UNITED STATES PATENT AND TRADEMARK OFFICE

| APPLICATION NO. | FILING DATE | FIRST NAMED INVENTOR | ATTORNEY DOCKET NO. | CONFIRMATION NO. |
|-----------------|-------------|----------------------|---------------------|------------------|
| 10/619,017 | 07/14/2003 | Stephen C. Thatcher | 10,220 | 8801 |

| Office Action Summary | Application No. 10/619,017 | Applicant(s) THATCHER ET AL. | |

DETAILED ACTION

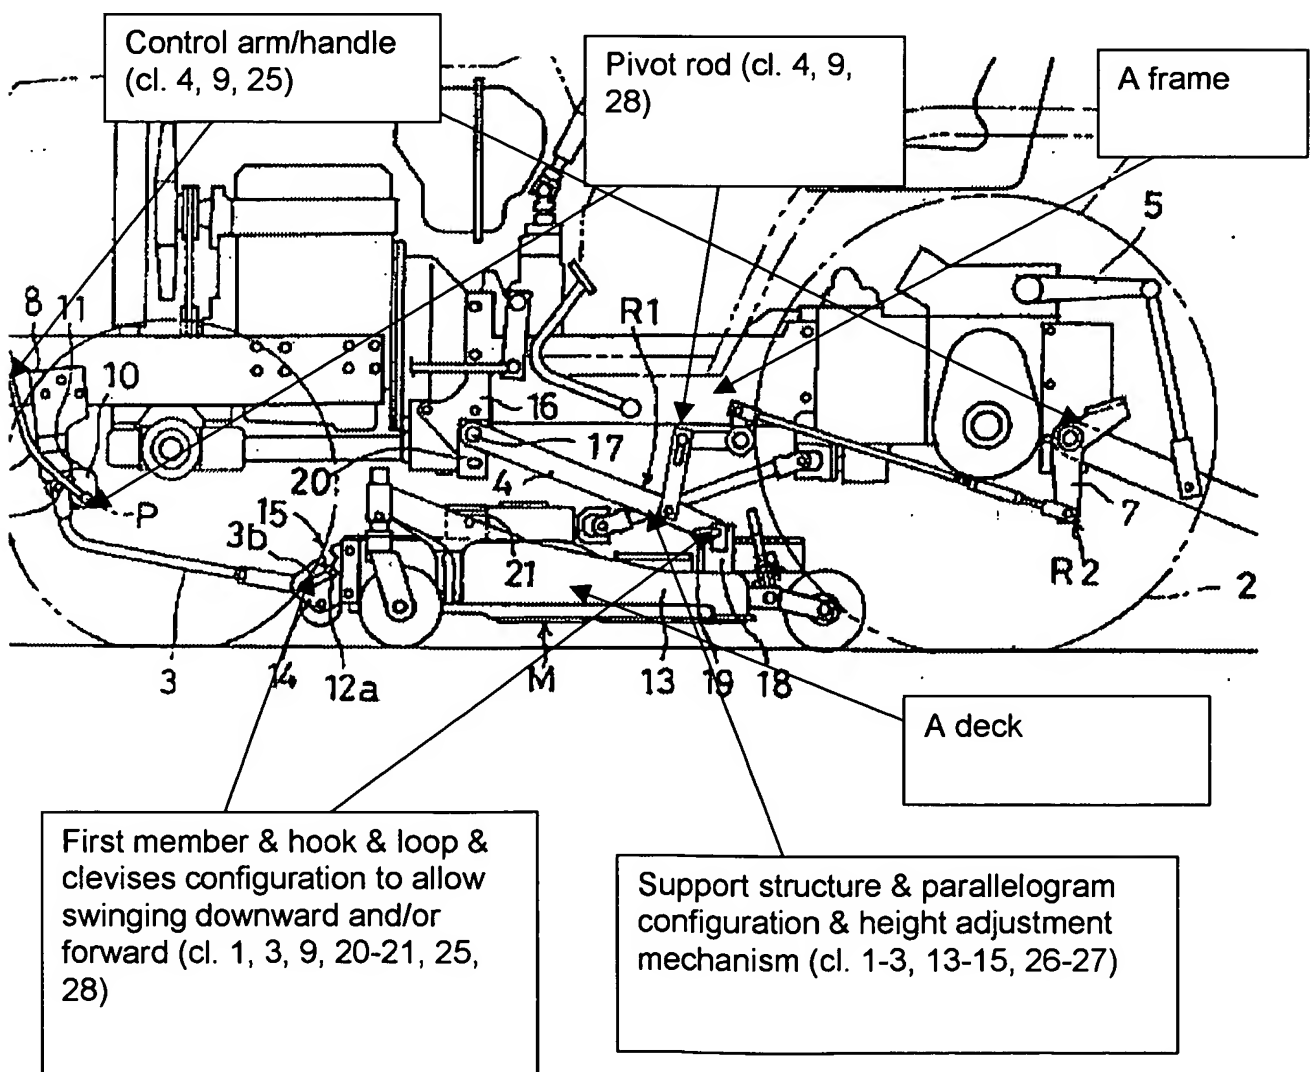
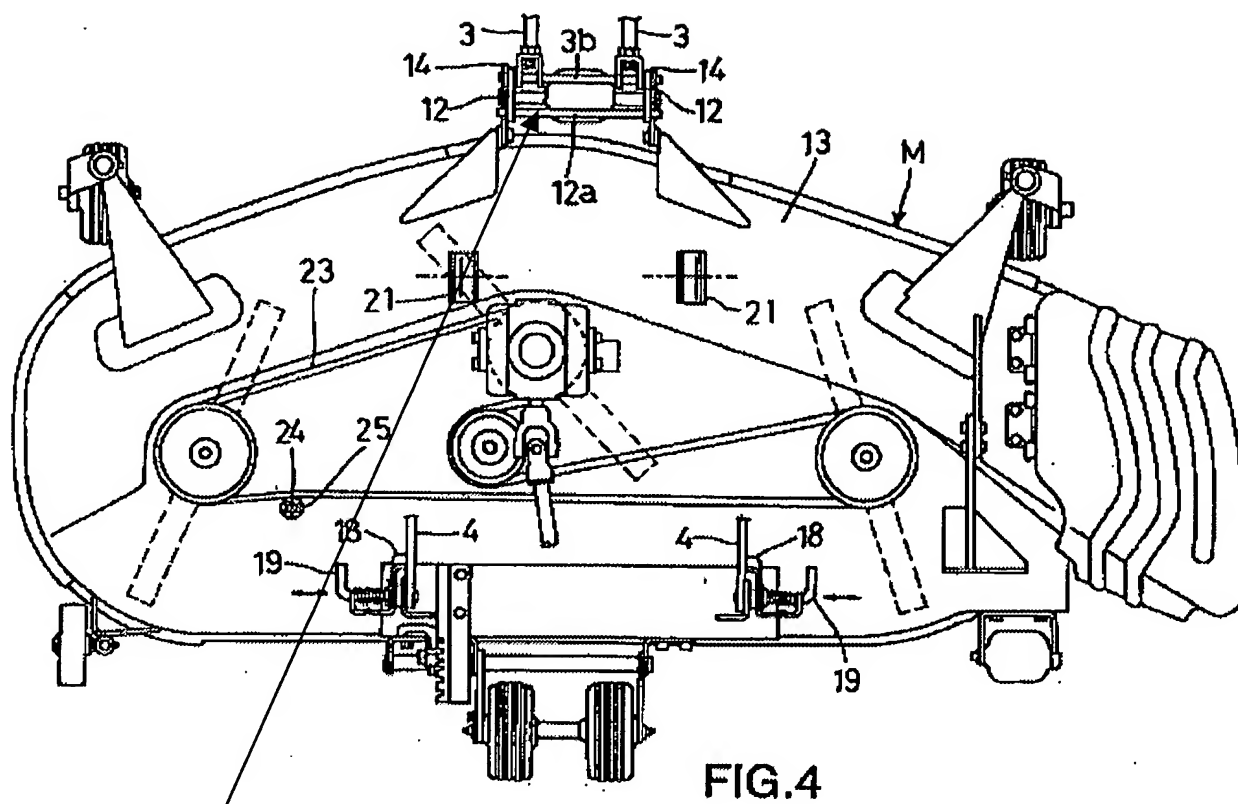
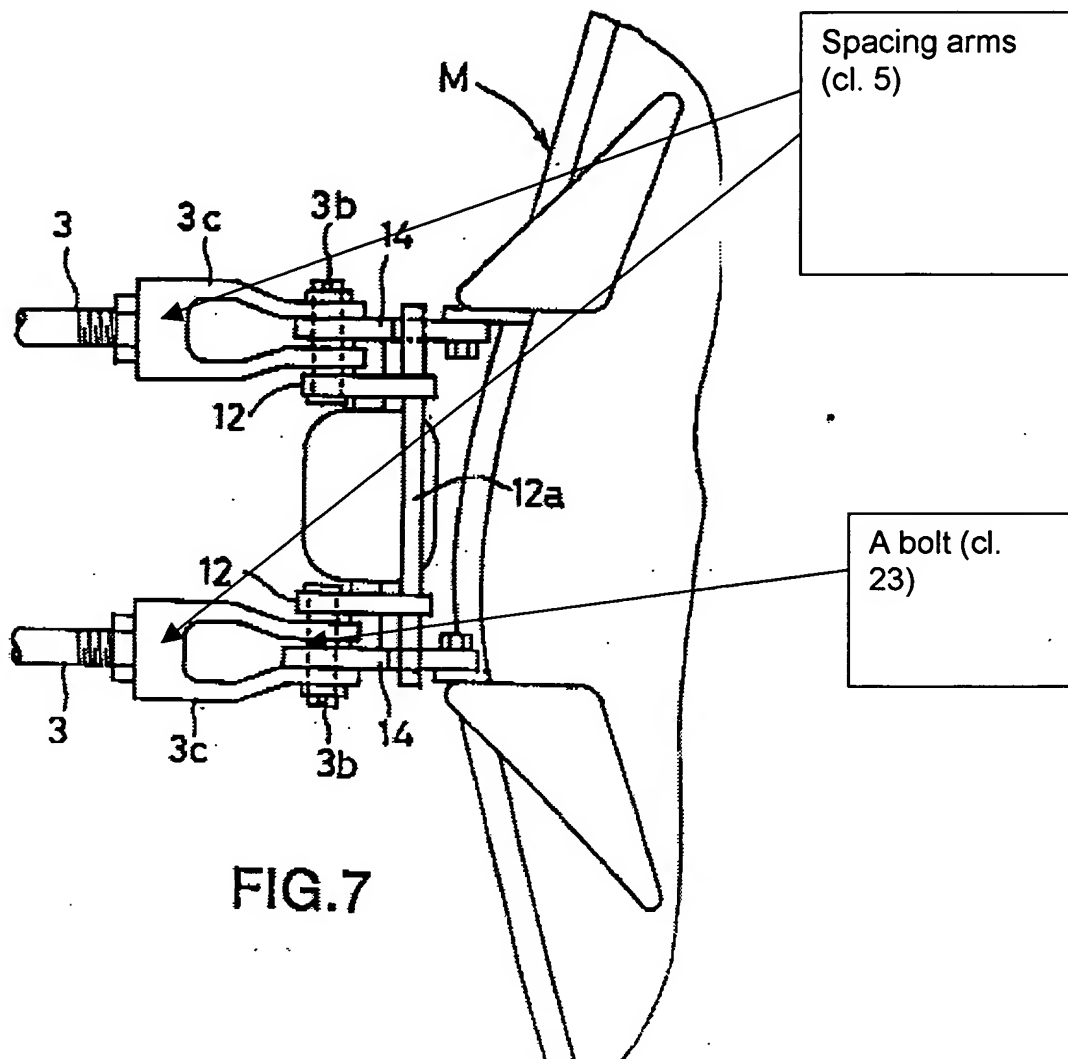
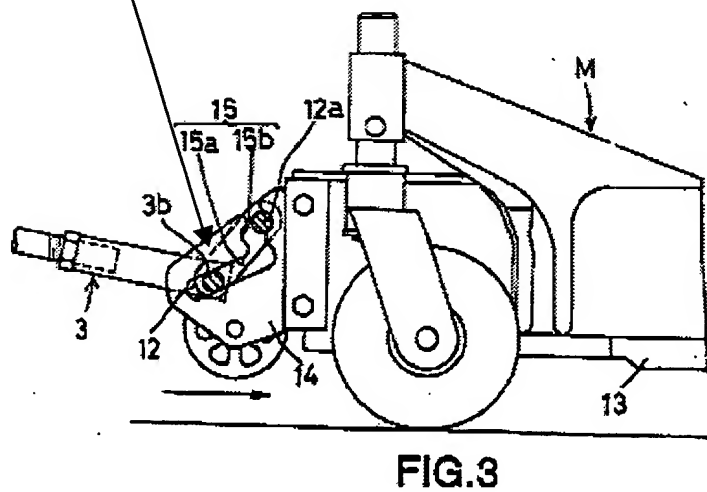
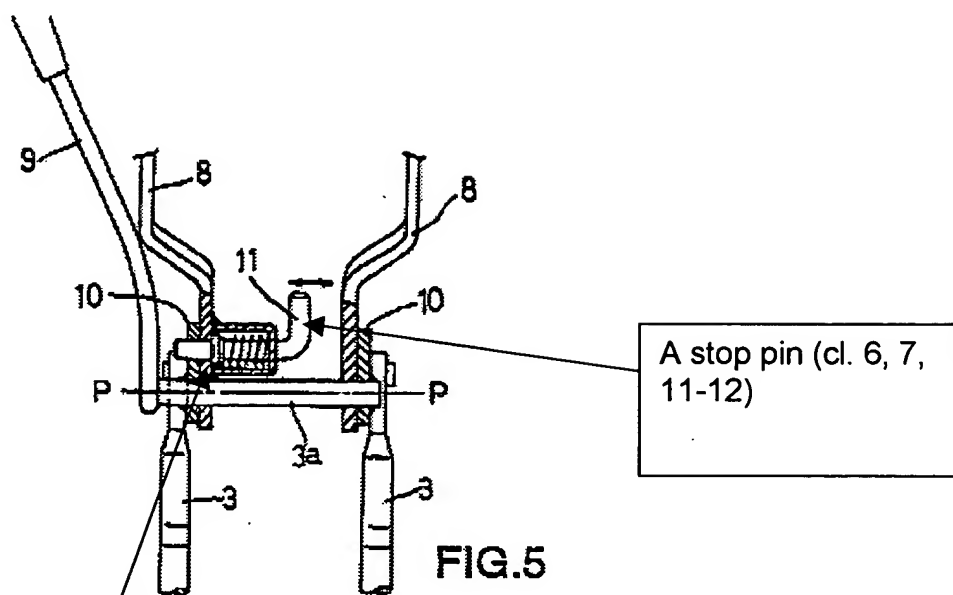
10. Claims 1-16, 20-28 are rejected under 35 U.S.C. 102(b) as being anticipated by Kure et al (5528889).

Kure discloses as best shown in the marked up drawings below for greater clarity:

A pivot rod/bail (cl. 4, 10,
25, 28)
